CVS Derwood: Site Plan No. 820160150

Staff Report Date: 12-02-16

Request to construct a 9,965 square foot Drug Store, located at 17647 and 17651 Redland Road in the southeast quadrant of the intersection of Redland Road and Muncaster Mill Road (MD 115), 1.24 Acres, Commercial Residential Town Zone, 2004 Upper Rock Creek Master Plan.

Staff Recommendation: Approval with Conditions

SHEET NUMBER: **C-4**
OF 7

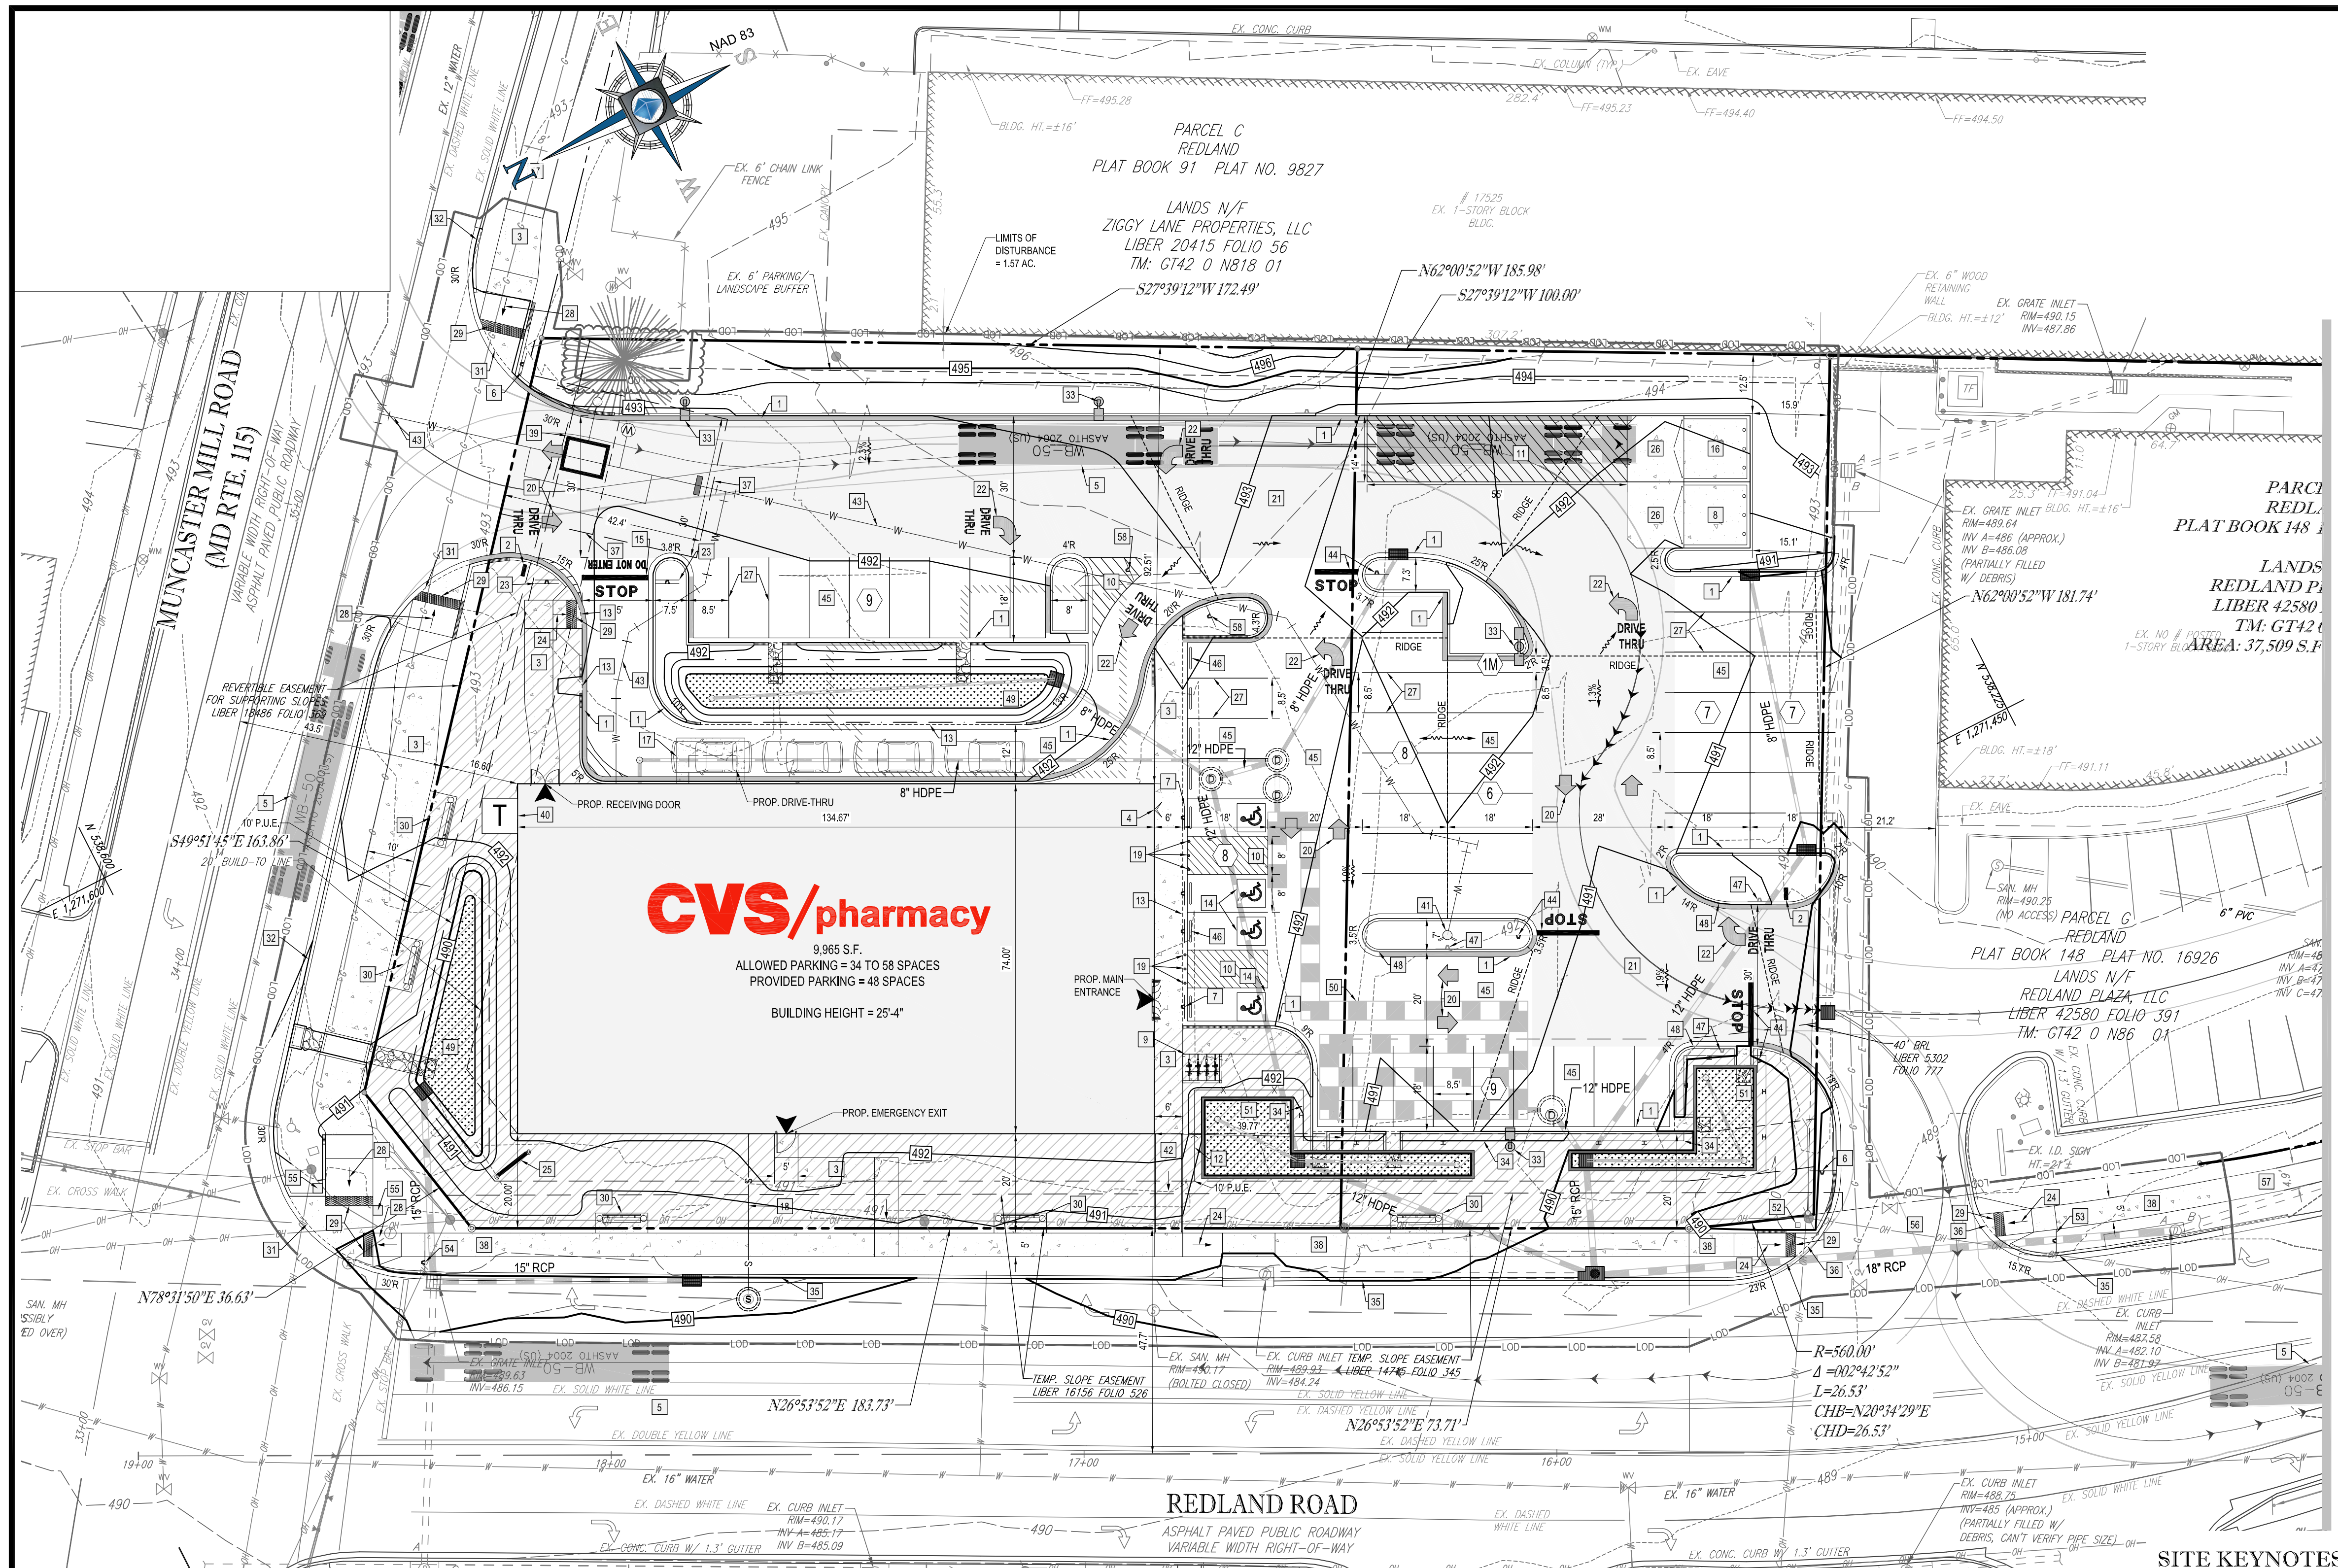
- a. The Applicant must clearly show on the Certified Site Plan ADA-compliant with adequate pavement markings and signage alerting motorists entering the drive-through lane of pedestrian crossings.
- b. The Applicant must provide and show on the Certified Site Plan four invert-U bike racks (or equivalent as approved by the Planning Board staff) as a replacement for the proposed wave bike racks.

1. ADA-compliant and adequate pavement marking and signing, warning motorists entering the drive-through window of pedestrians at the eastern terminus of the internal sidewalk in front of the pharmacy main entrance.
2. Four invert-U bike racks (or equivalent as approved by the Planning Board staff).

LANDSCAPE
PLAN

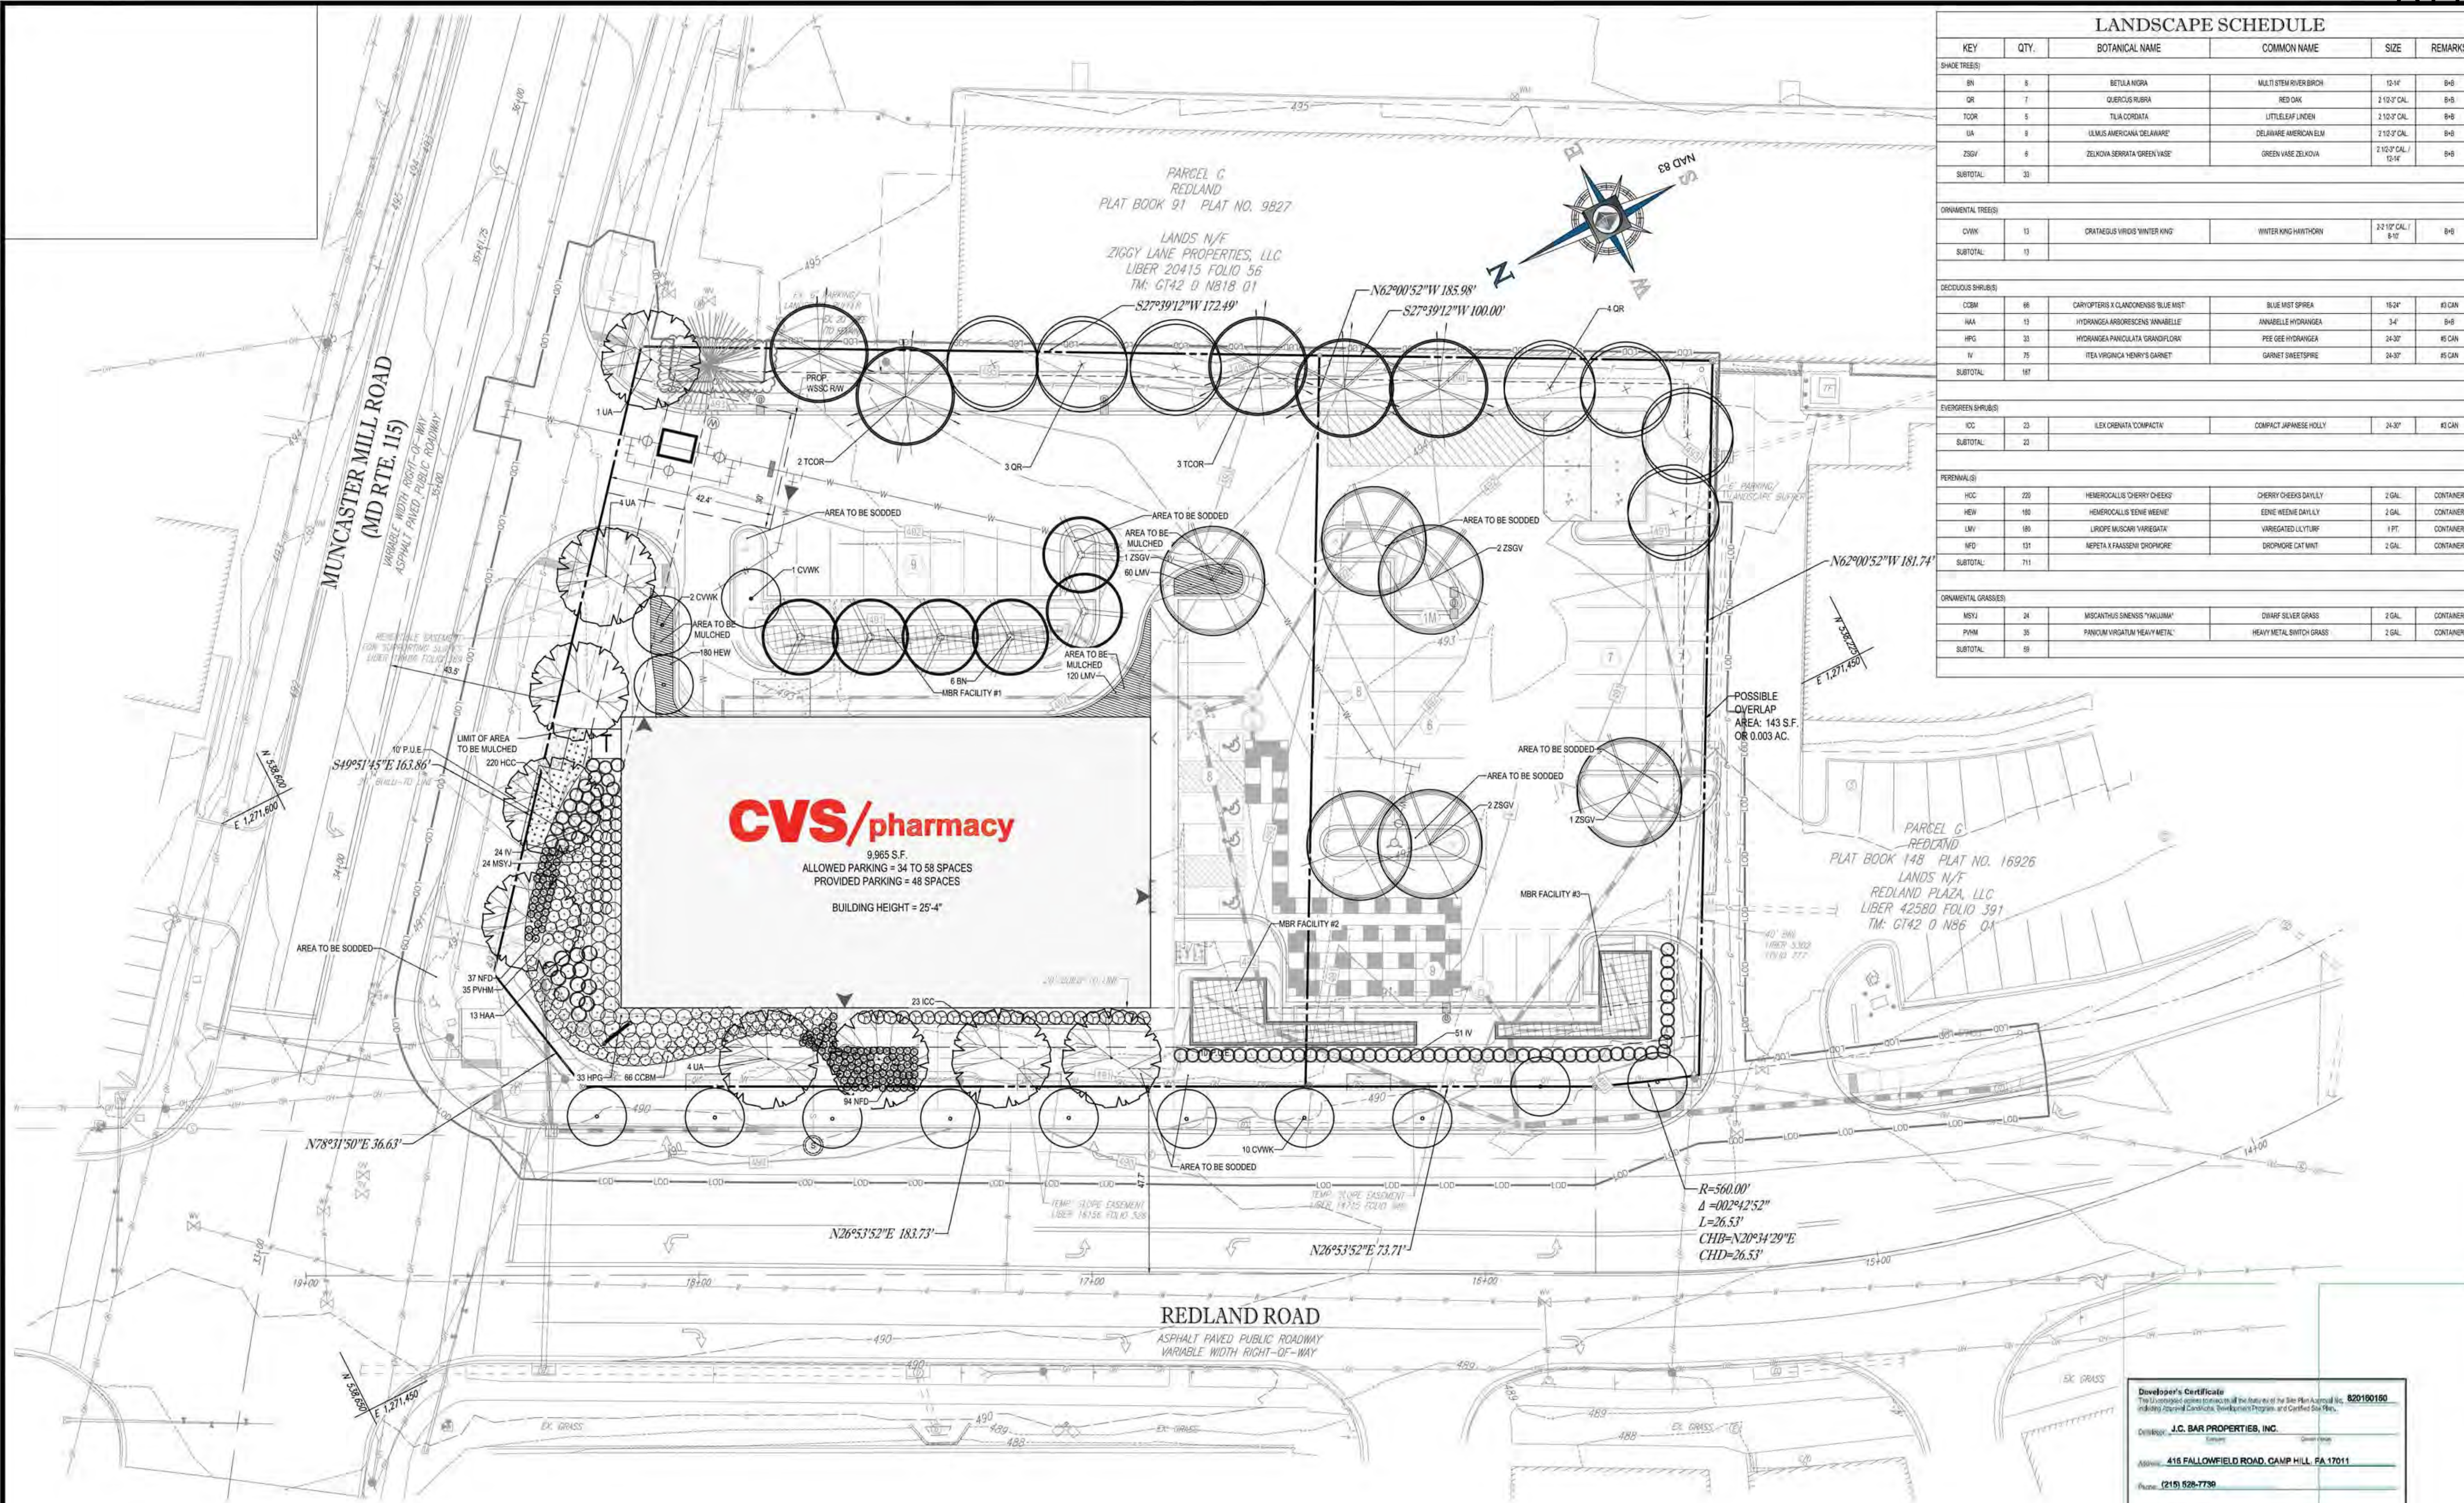
- g. The Photometric Plan must be revised to ensure that the illumination levels do not exceed 0.5 footcandles or less at the lot line.
- h. Final landscaping must be substantially similar to Landscape Plan sheet number LS-1, with a revision date of October 28, 2016.
